**OCTOBER 23, 2013**

**ADDENDUM NO. 1**

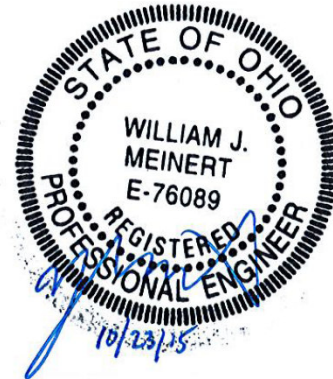
CITY OF MASSILLON 2013 WWTP IMPROVEMENTS  
 CONTRACT NO. 2 – GENERAL CONSTRUCTION  
 ADDENDUM NO. 1  
 PAGE 2 OF 15
